APPLICATION OVERVIEW

SITE PLAN REVIEW (§ 5.3)

DRB DOCKET #:	DRB-20-07
APPLICANT(S):	Ross Brewer
CONSULTANT(S):	Jay Meadows, Exemplars Peter Mazurak, TCE Engineering Scott Pike, Larson Construction
PROPERTY ADDRESS (PARCEL ID CODE):	413 Vermont Route 15 (VT413)
ZONING DISTRICT(S):	Underhill Flats Village Center District
INITIAL FILING DATE:	Monday, June 15, 2020
APPLICATION COMPLETION DATE:	Monday, June 15, 2020
SCHEDULED HEARING DATE:	July 20, 2020

ROSS BREWER
SITE PLAN REVIEW
Docket #: DRB-20-07

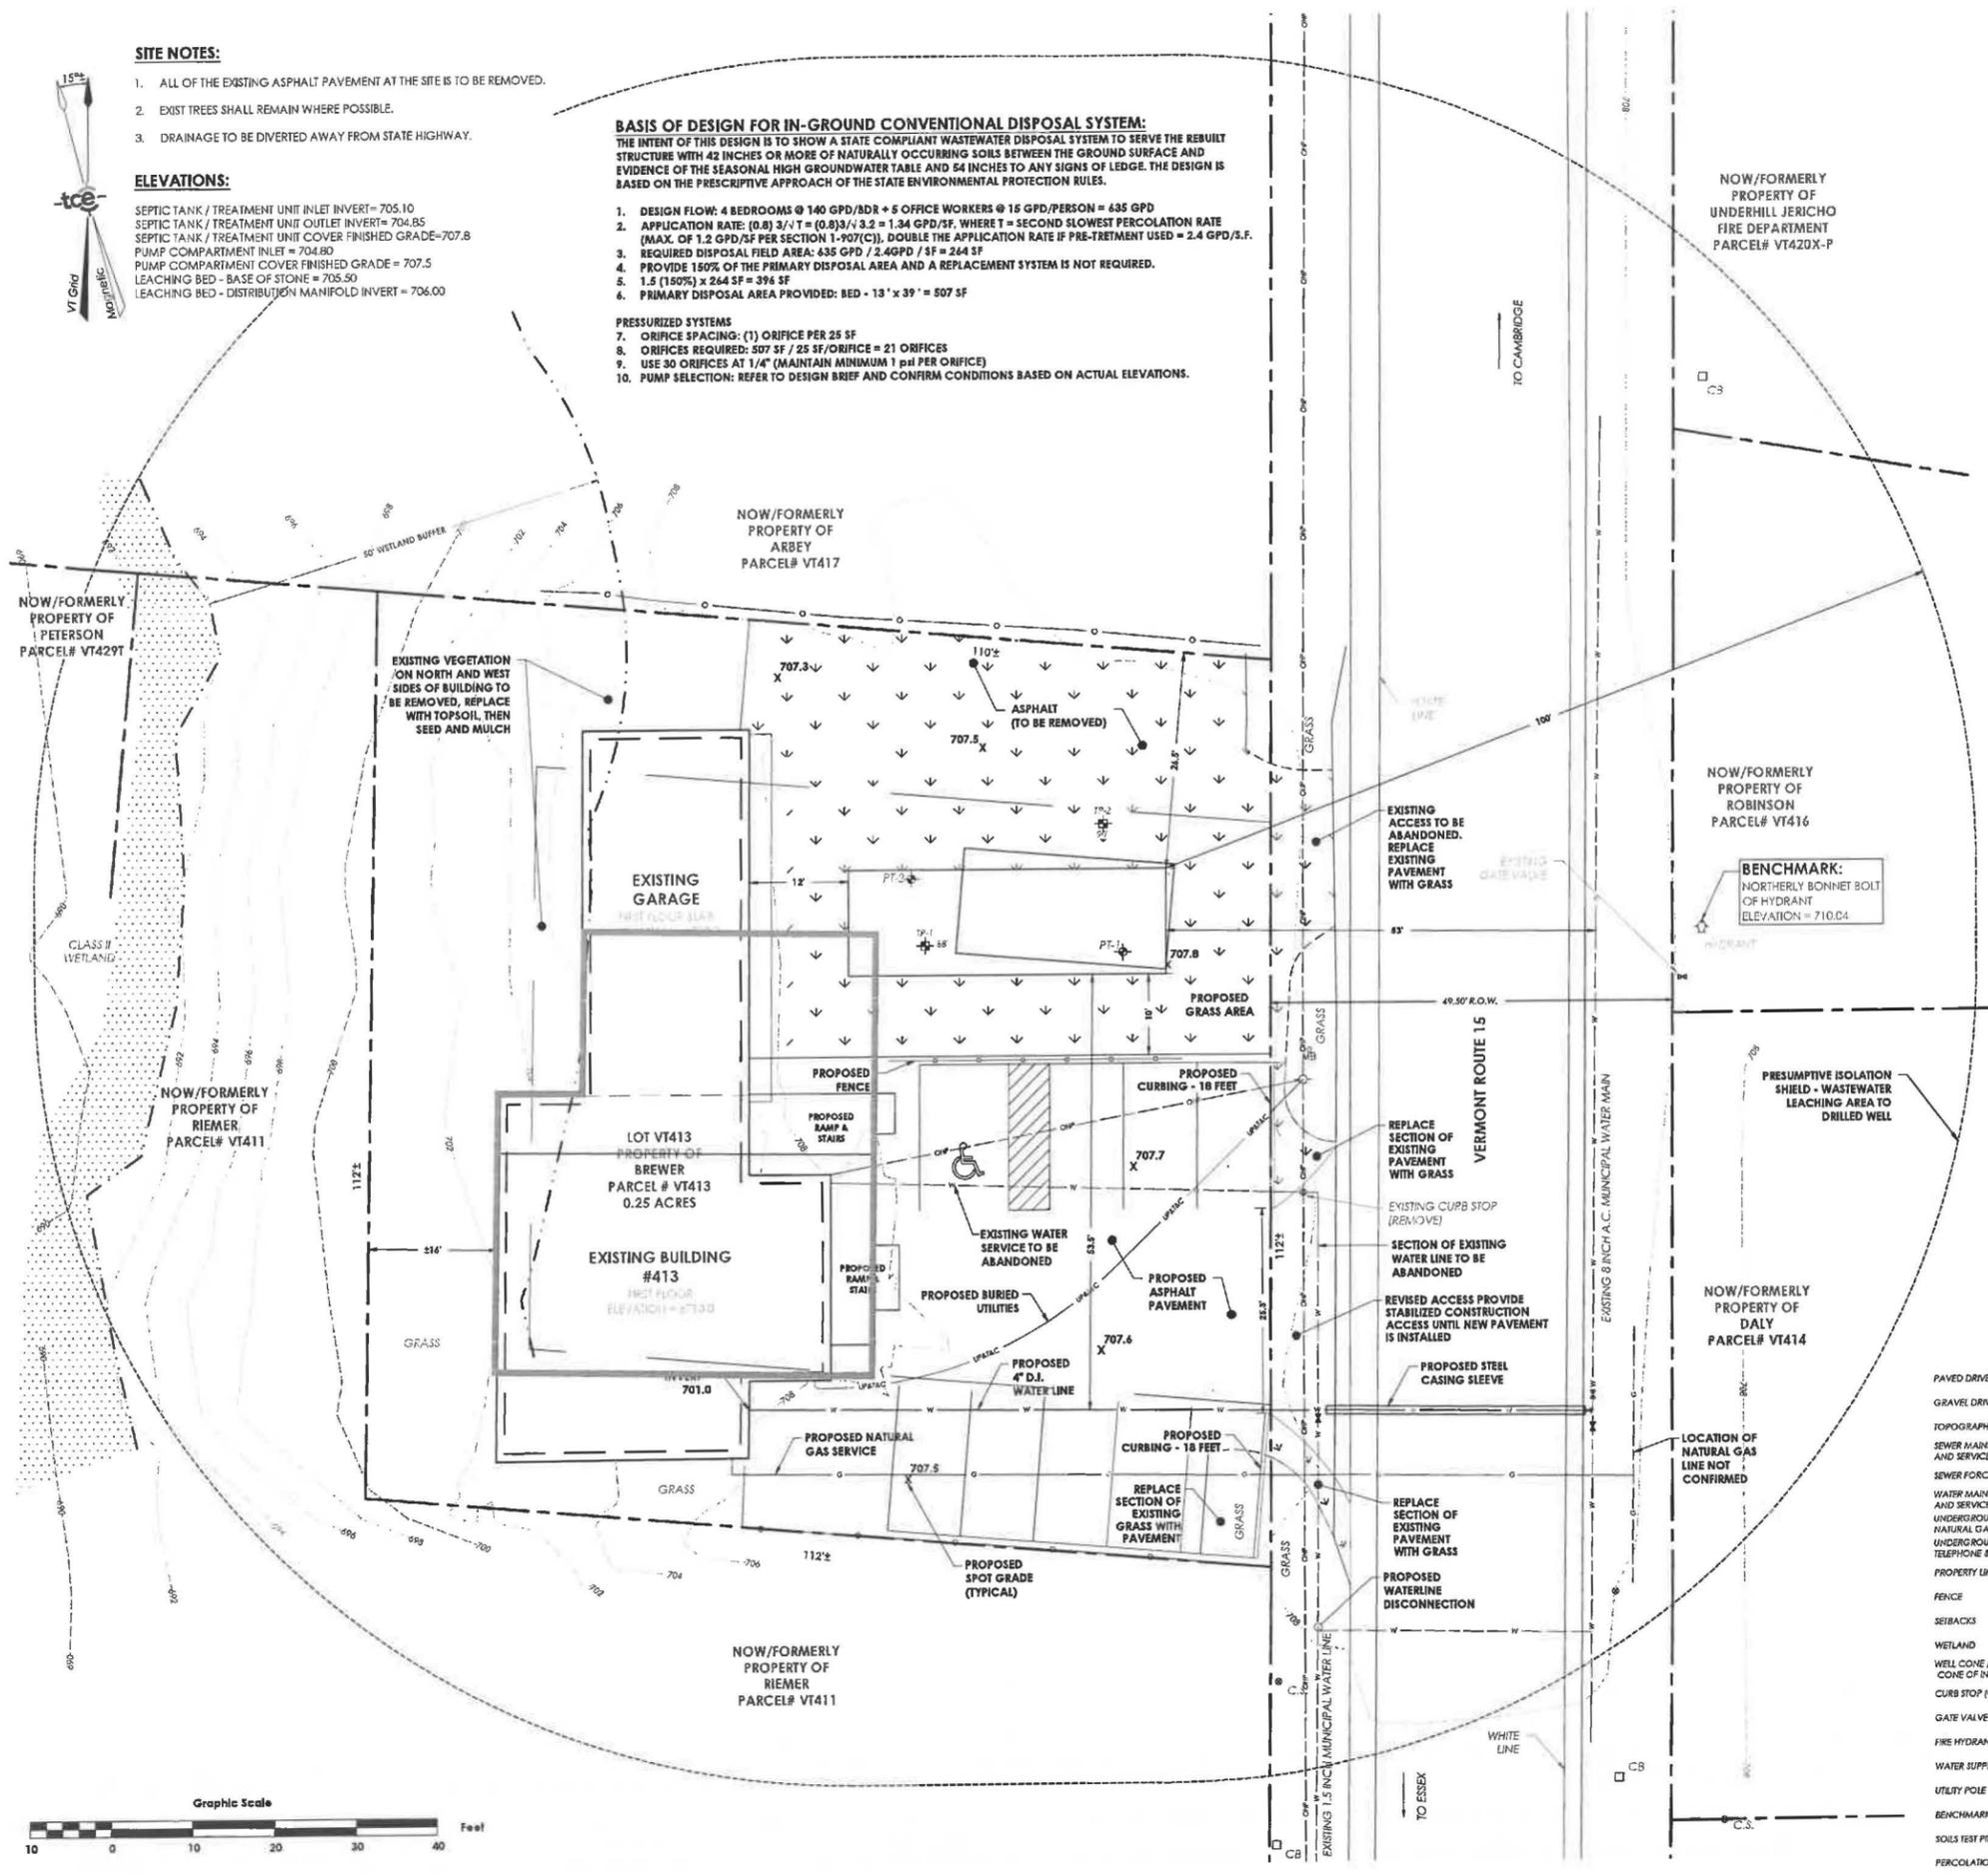
- b. The proposed office building will fail to satisfy the south side property setback requirement, as well as the west rear property setback requirement.

- b. The nearest part of the parking lot is ± 1 ft. from the south, side property line; therefore, is nonconforming with the 12 ft. setback requirement.

- c. The part of the parking lot that is to remain will remain nonconforming, as it will be ± 1 ft. from the south side property line, thus failing to meet the 12 ft. setback requirement.

- d. The western portion of the proposed building will be in a Class II Wetlands buffer. (see Section 3.19 below).
5. **SECTION 3.9 – NONCONFORMING STRUCTURES:**

9. **SECTION 3.19 – SURFACE WATERS & WETLANDS:** While the Applicant is not proposing to enlarge the footprint of the previously existing structure, since the footprint of the building will be modified, verification from the State’s wetlands ecologist is recommended to ensure compliance.

10. **SECTION 3.23 – WATER SUPPLY & WASTEWATER SYSTEMS:** Staff is uncertain as to whether a new Wastewater System & Potable Water Supply permit needs to be submitted to the State and approved due to the changes with the proposed project.

- b. The Board should inquire with the Applicant what the turning radii is.
 - c. Curbing shall be a minimum of seven inches in height, granite, and either vertical or sloped.

- d. The Board should inquire about drainage patterns, especially with the addition of curbs.
 - e. The Board should inquire about banks and ditches.
 - f. Comments from the Road Foreman will need to be solicited and will be subsequently entered into the record.

14. **SECTION 5.A – DRIVEWAYS:**
 - a. The entrance to the parking area is located approximately 19 feet from the south side property line; however, fails to satisfy the setback requirements of the district (though the parking lot is already nonconforming).
